ADDENDUM #1

PROJECT: PRIDE FIRE DISTRICT - INDIAN MOUND STATION CITY PARISH PROJECT NO. 21-ASC-CP-1580

ADDENDUM NO. 1

Pride/EMS Station

1 Power Plan
1/8" = 1'-0"

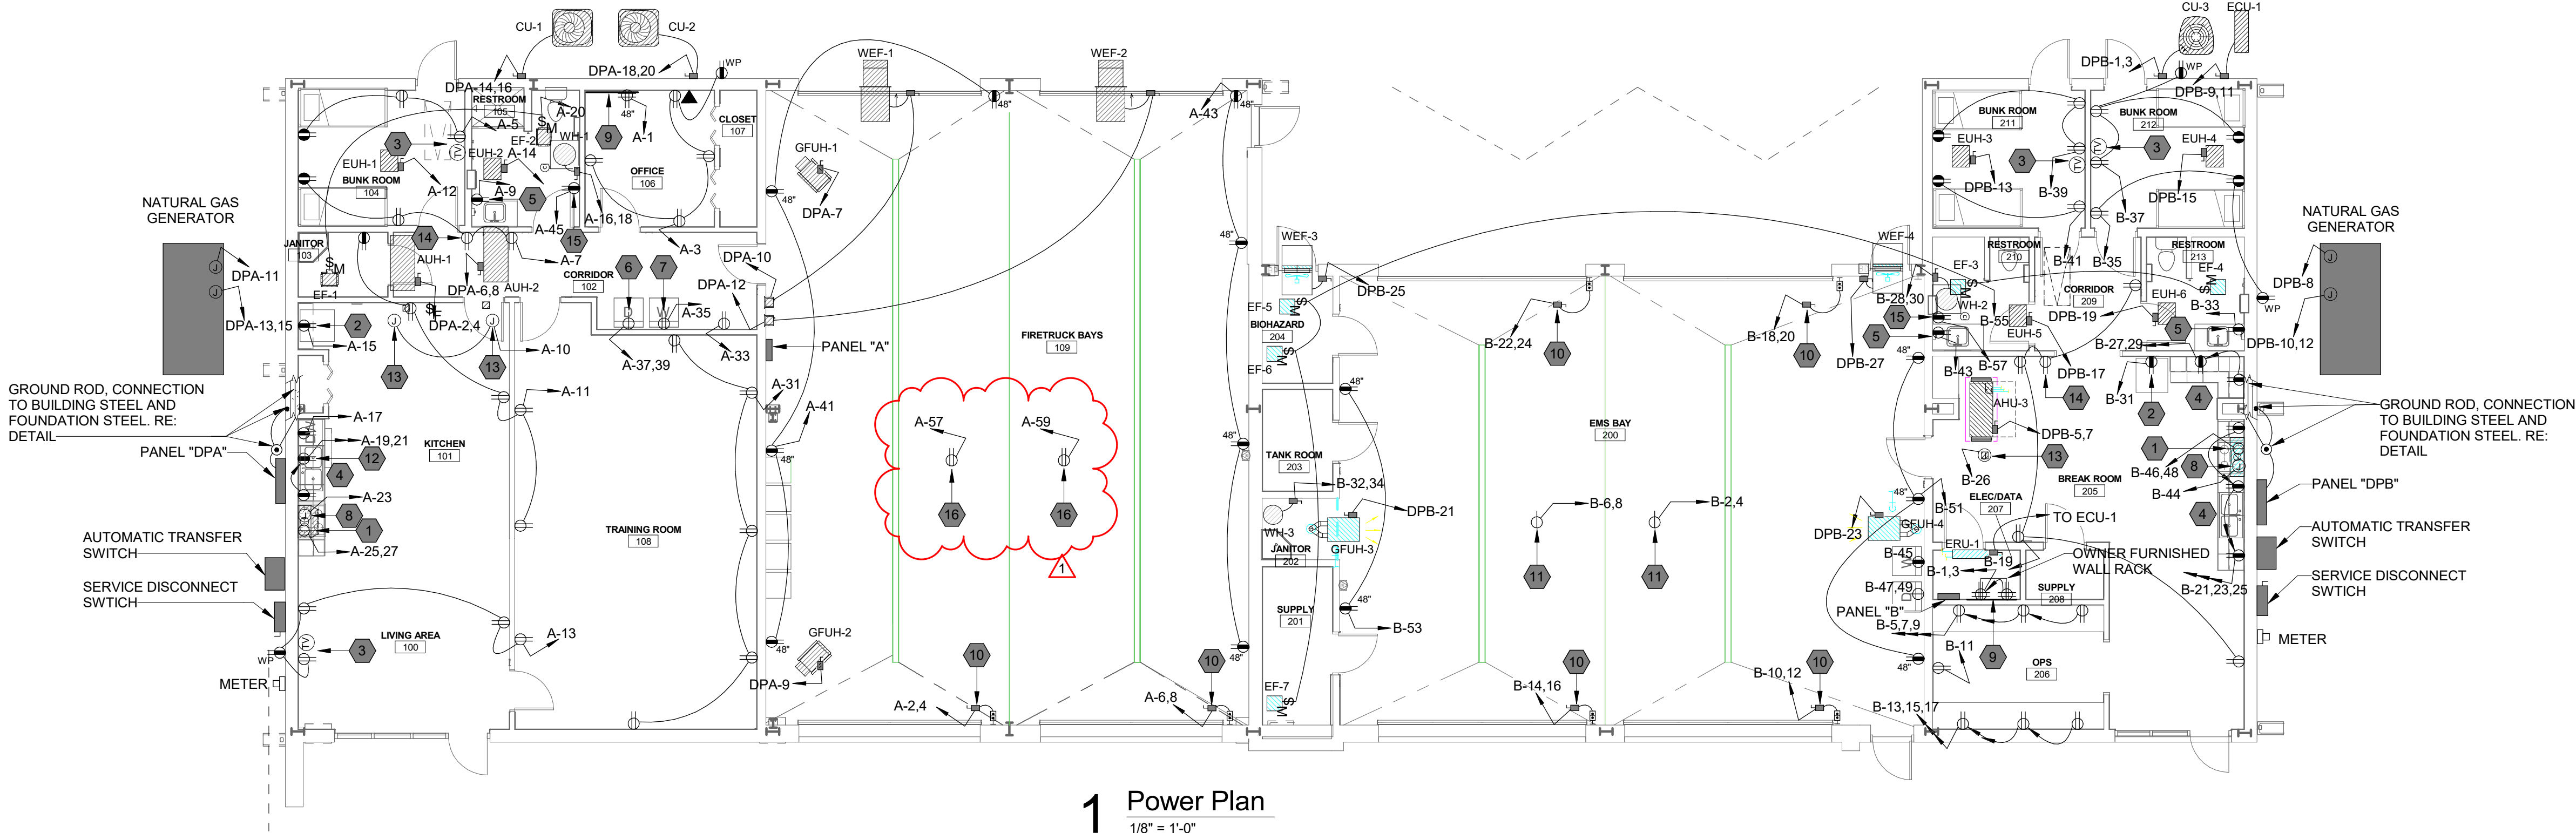
- Please see attached updated Electrical drawing sheets E2.01 and E4.01
